# NATIONAL BOARD SUBCOMMITTEE PRESSURE RELIEF DEVICES

## **MINUTES**

Meeting of July 20, 2016 Columbus, OH

# FIGURE 5.7.5-f REQUIRED MARKINGS FOR NUCLEAR REPAIRS OR REPLACEMENTS

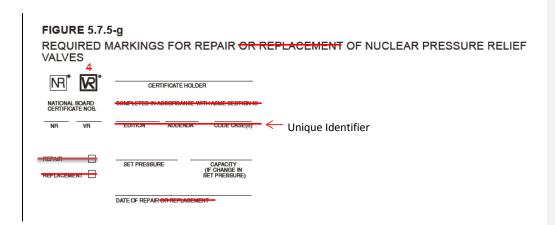
NB16-1501 NR Task Group 7-18-16

Comment [TB1]: Can be added back in if item NB16-0603 gets approved.

Note 4: For Group 3, see Part 3, \$9.3 a)
